**Before the Hearing Panel appointed by Canterbury
Regional Council**

**AND
IN THE MATTER OF** Applications CRC204106,
CRC204107, CRC204143,
CRC211629 and RC205104 to
establish, operate, maintain
and rehabilitate an aggregate
quarry by Taggart Earthmoving
Limited

SUMMARY STATEMENT

**SECTION 42A REPORTING OFFICER
WAIMAKARIRI DISTRICT COUNCIL
PUBLIC WATER SUPPLY AND FLOODING – KALLEY SIMPSON**

Attachment 1 – Rangiora Public Water Supply – Flow Diagram

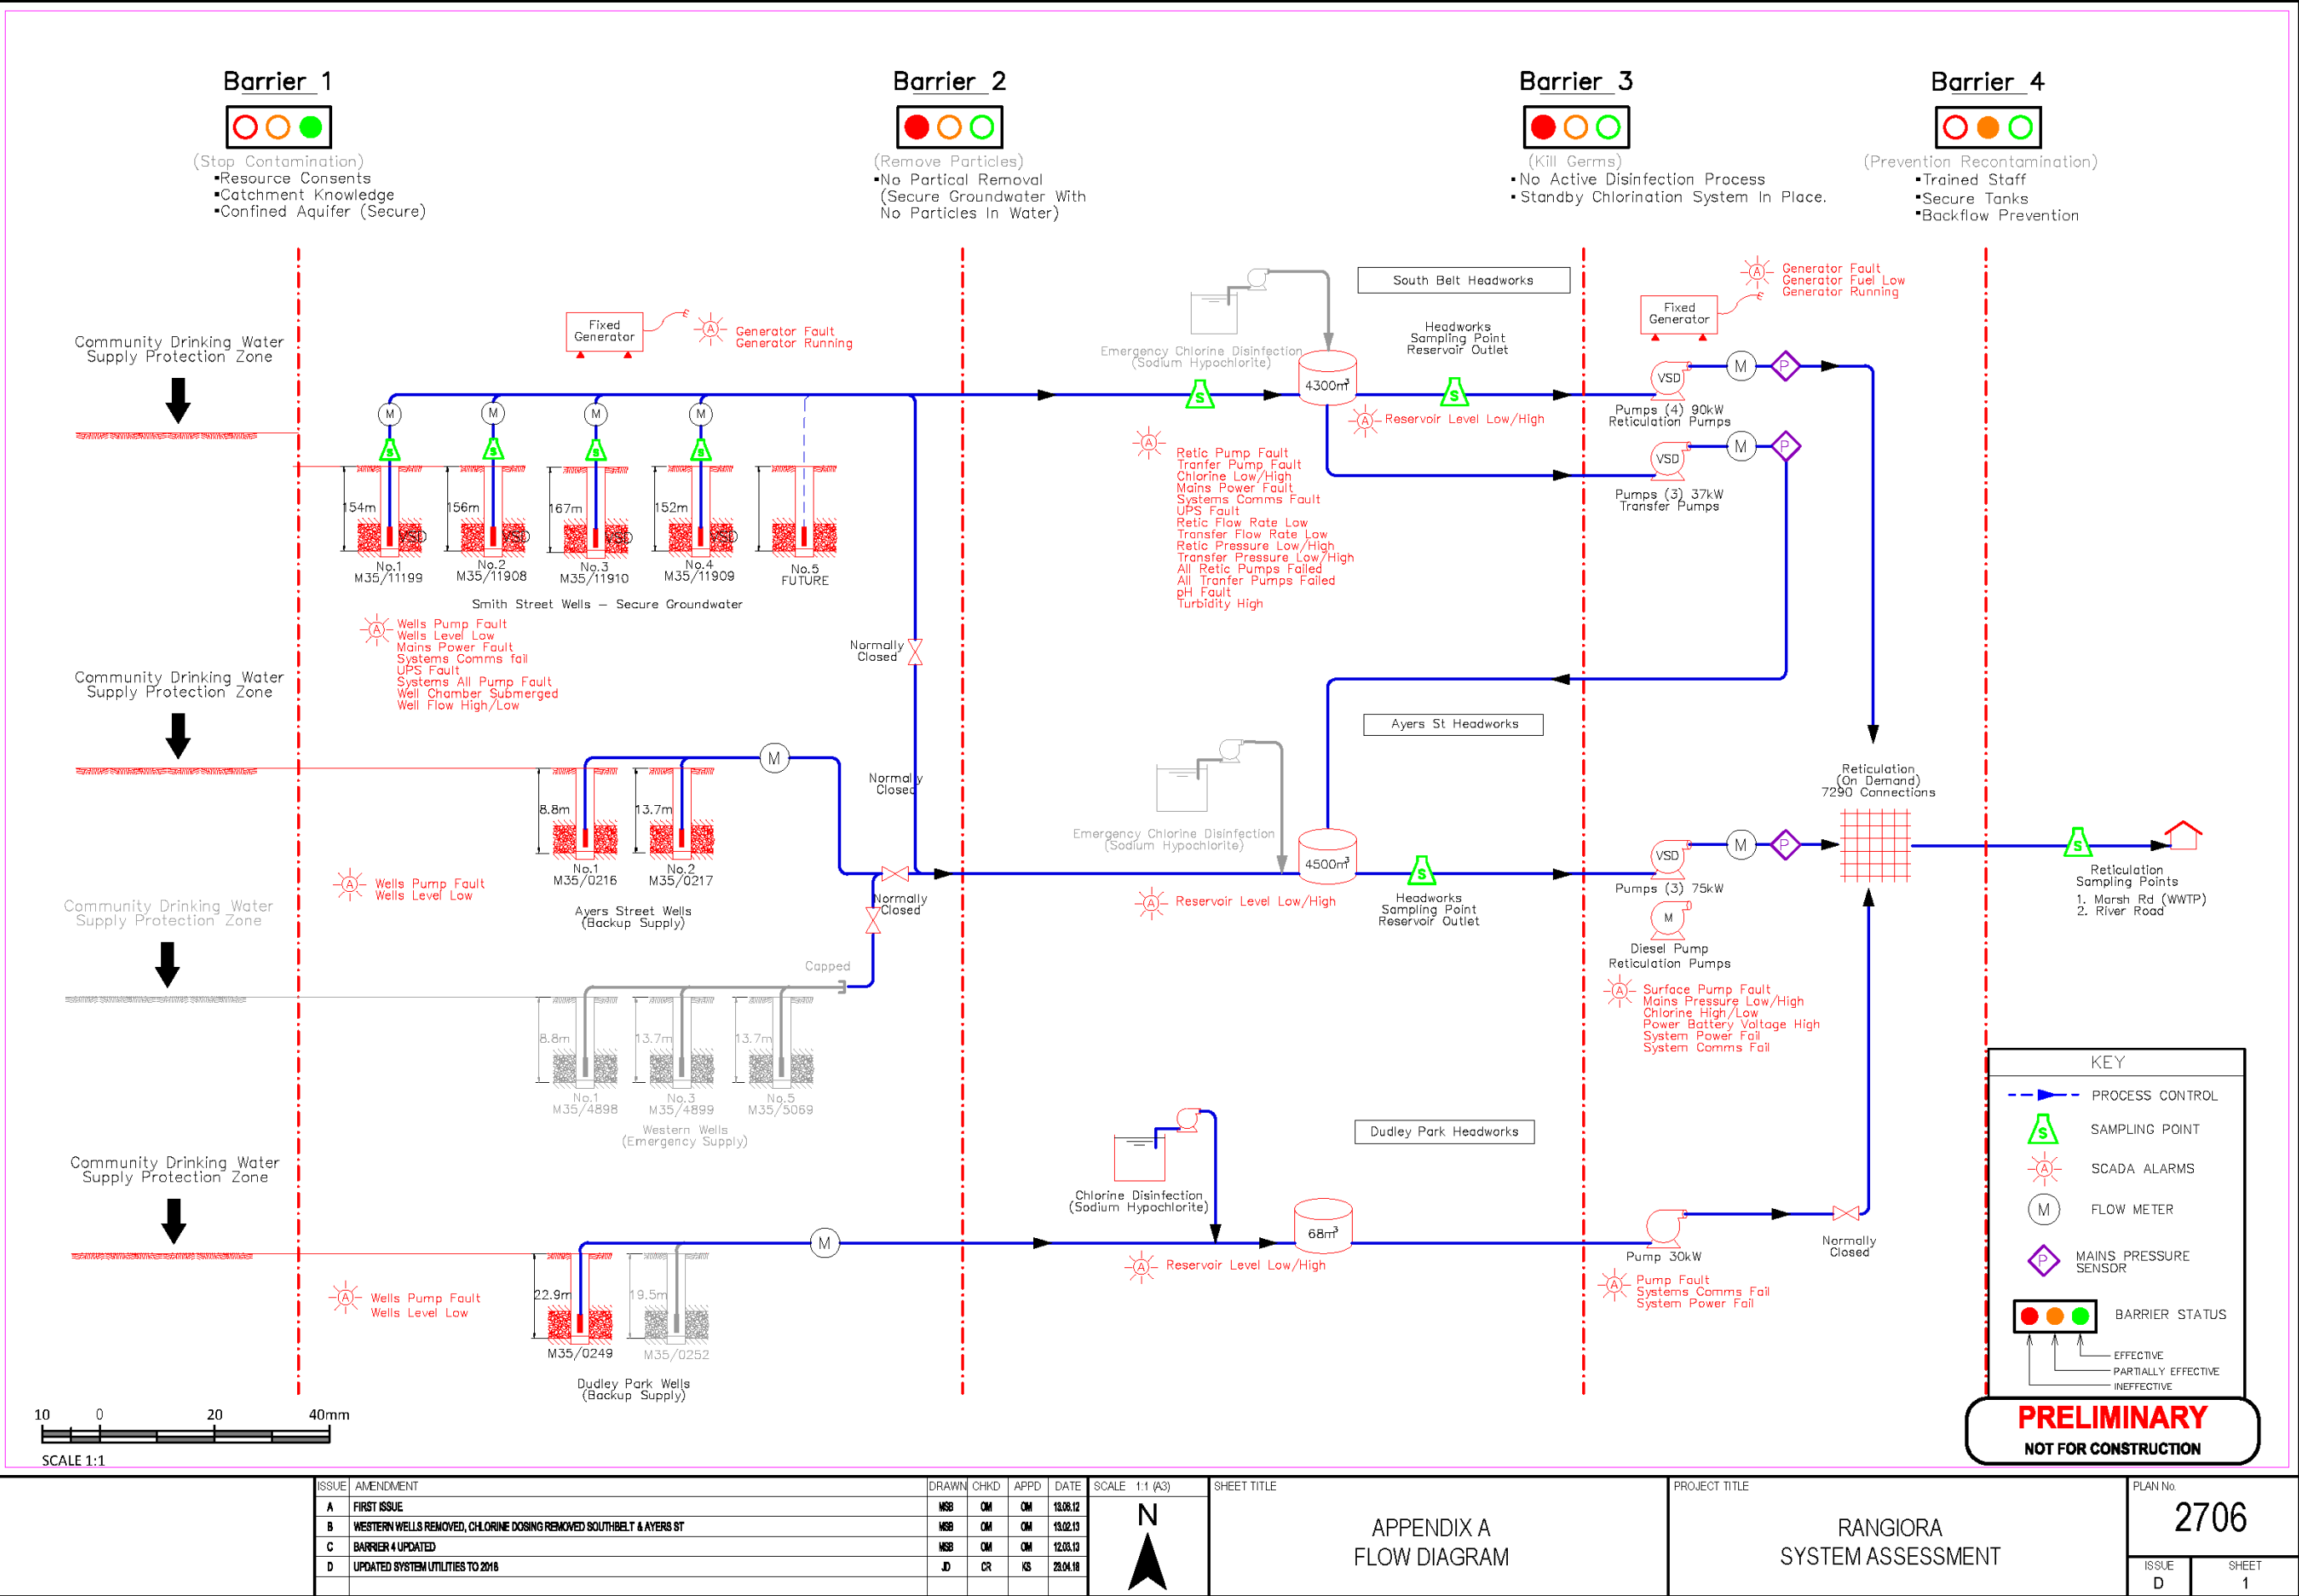
Western wells pipeline is capped and some of the infrastructure has been removed, however it is in a state where it could be used at short notice. A schematic of the system is shown in Attachment 1, which is an extract from the Rangiora Water Safety Plan 2018. It is noted that this diagram shows that the first barrier in providing safe drinking water is to stop contamination occurring within the catchment.
